LAND AND ENVIRONMENT COURT OF NSW FILED ON 23 MAR 2018	
	INT

AGREEMENT BETWEEN THE PARTIES

Court Land and Environment Court of New South Wales
Class 1
Case number 2017 / 268600

NSWLEC Proceedings No. 2017 / 268600

SHEET 2 OF 7 SHEETS

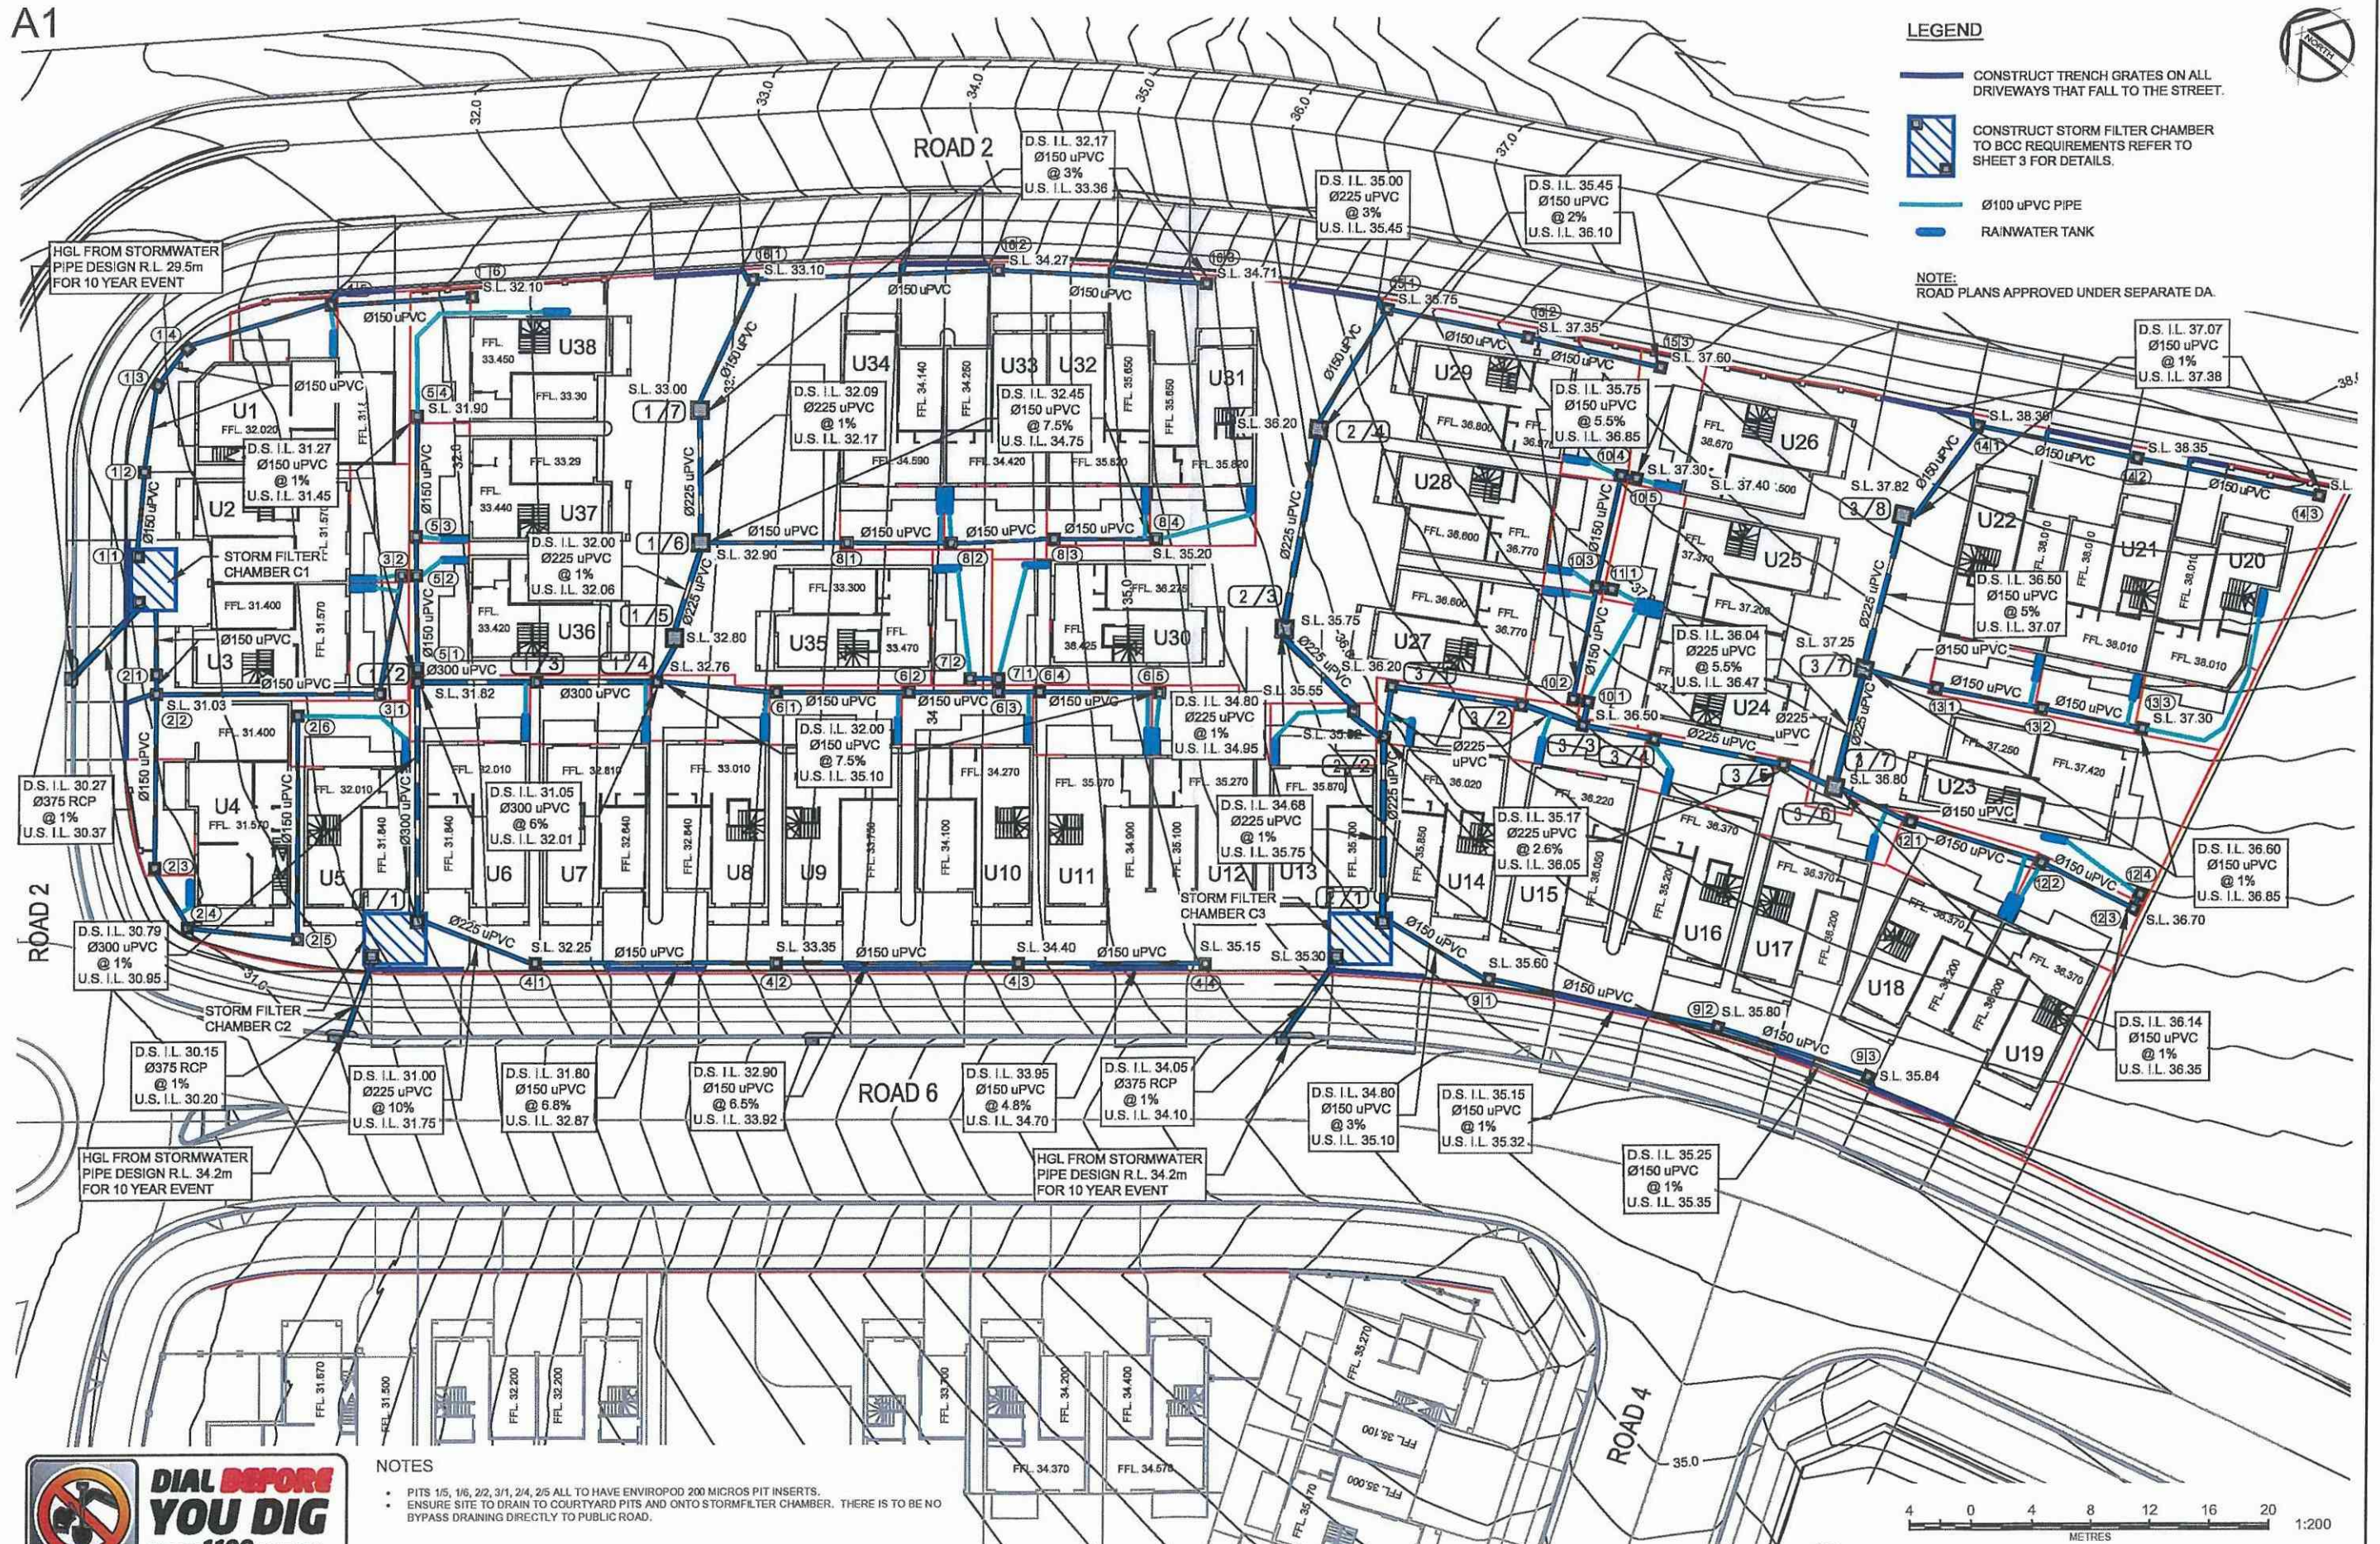
- xiii. On Dwg Nos SY170226C800 Rev B Sheet 2 provide a depressed (by minimum 100 mm) inlet pit in the front southern yard of unit 19.
- xiv. On Dwg Nos SY170226C800 Rev B Sheet 2 provide minimum 150 mm kerbs along the southern side/rear boundaries of units 19, 21 and 23 and the courtyard boundaries of units 1 and 4.

- xv. On Dwg Nos SY170226C800 Rev B Sheet 2 amend note at bottom to include Enviropods at pits 1/7, 2/3, 3/6, 3/7 and 3/8. Delete references to Enviropods at pit 2/2, 2/5 and 3/1.

Plan No.
SY170226C804
File Ref.
SY170226C800-B.dwg
SHEET 4 OF 7 SHEETS
REV. **B**

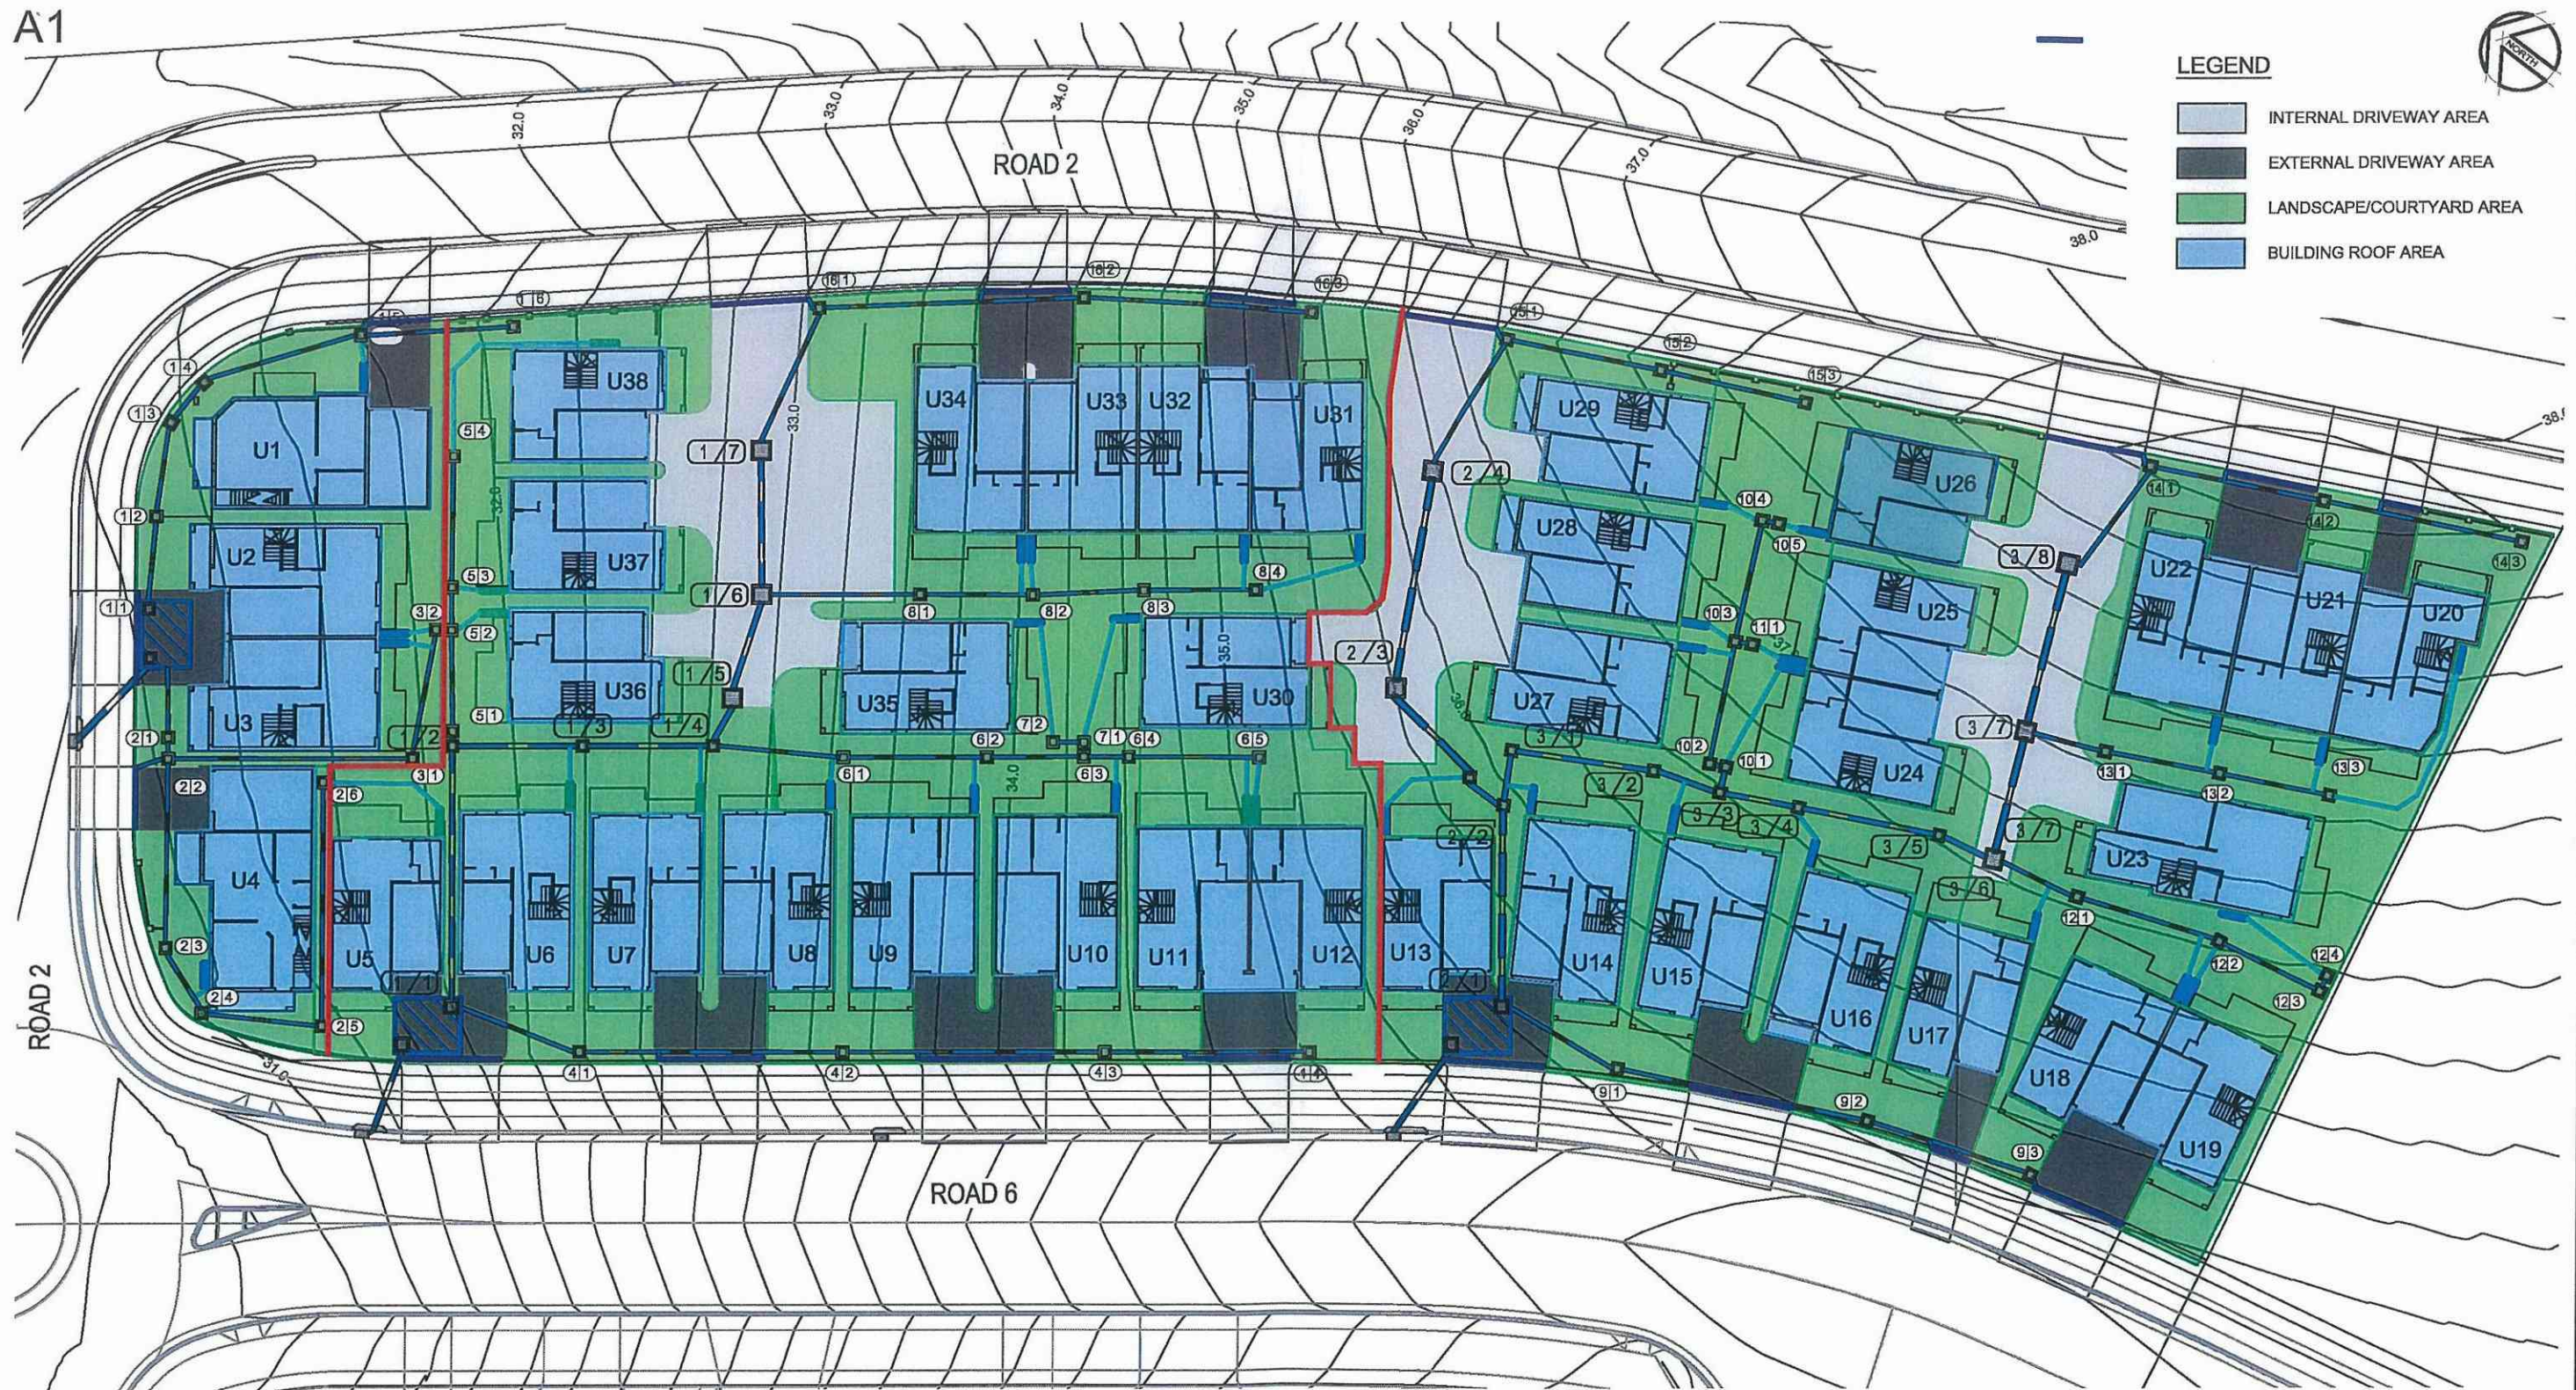
- xvi. On Dwg Nos SY170226C800 Rev B Sheet 4 amend the Water Quality Table to identify the correct lots draining to the Stormfilters C1, C2 and C3. Amend the correct number of Enviropods for C2 to 3 and C3 to 5.

Plan No.
SY170226C102
File Ref.
SY170226C100-B.dwg
SHEET 2 OF 6 SHEETS
REV. **B**

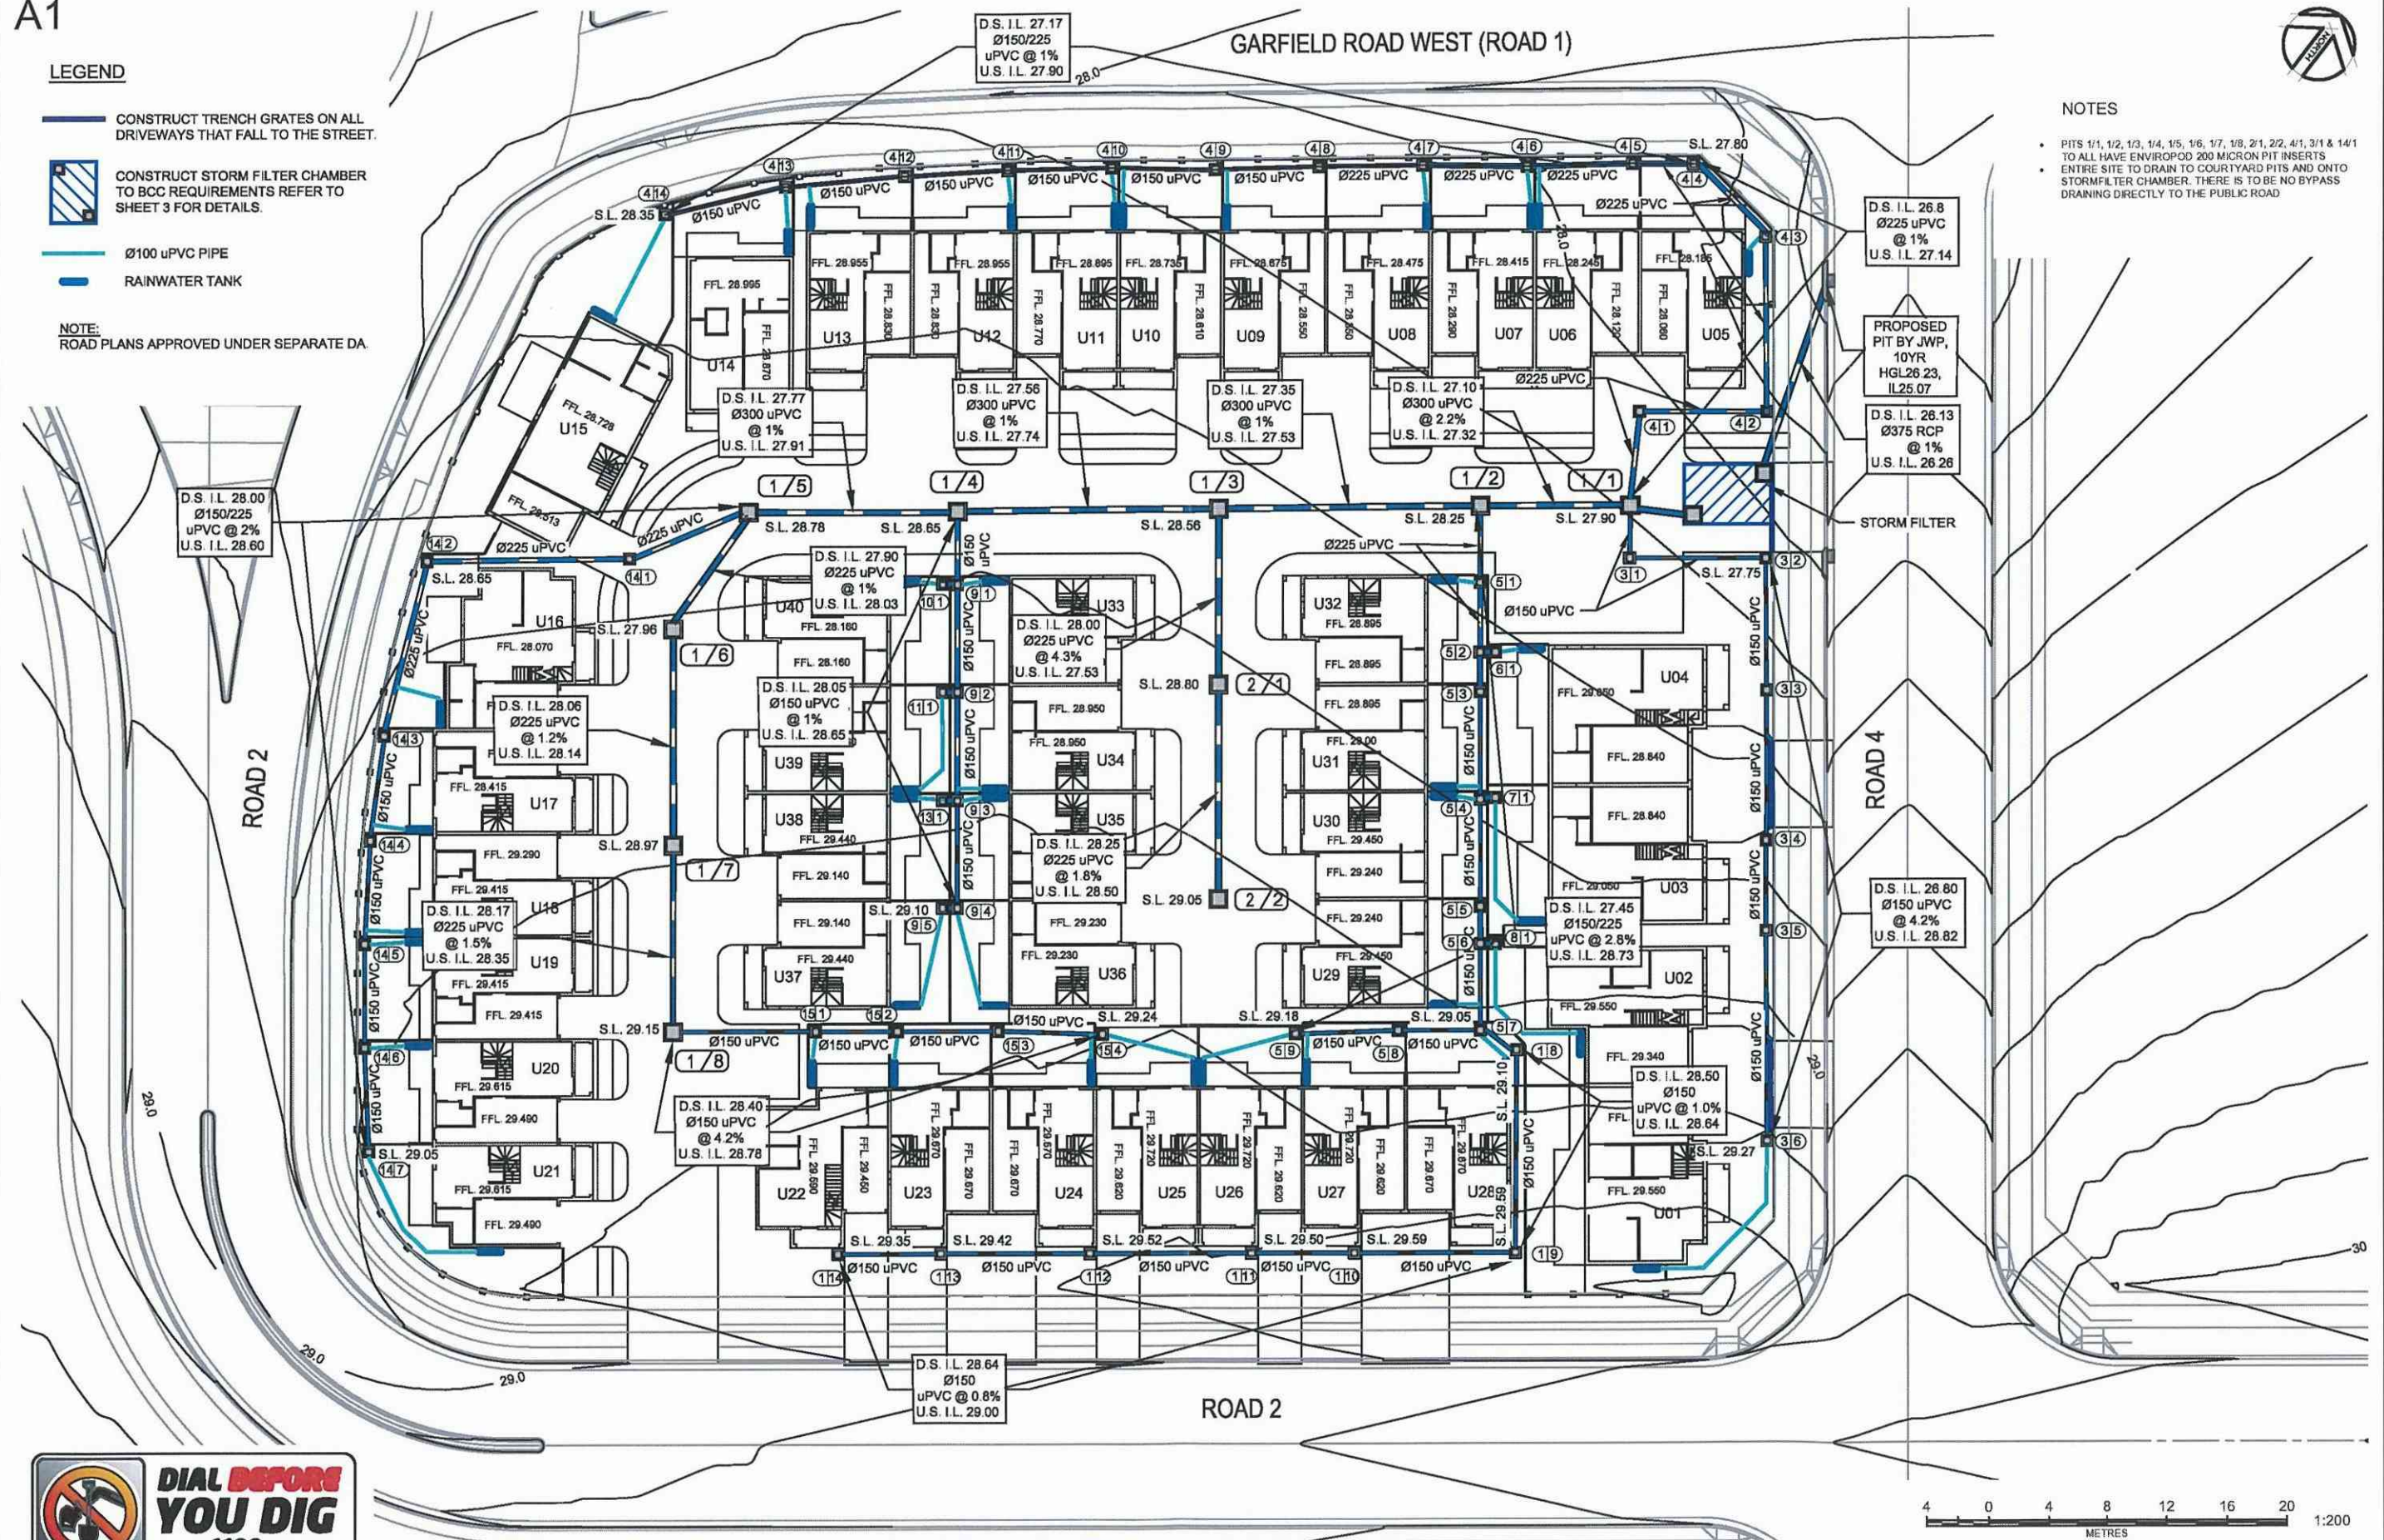
- xvii. On Dwg Nos SY170226C100 Rev B Sheet 2 show minimum 150 mm trench grates at the front driveways of units 22 to 28.
- xviii. On Dwg Nos SY170226C100 Rev B Sheet 2 provide minimum 150 mm kerbs along the rear boundaries of units 5 to 21 and the side boundary of unit 5.

- xix. On Dwg Nos SY170226C100 Rev B Sheet 2 increase pit sizes at 3/1, 4/1 and 14/1 to 900 x 900 to fit the Enviropods.
- xx. For each lot provide MUSIC catchment plans showing land use and what areas go to which different devices including rainwater tanks. Differentiate between roof draining to the rainwater tank and roof bypassing. Provide areas.
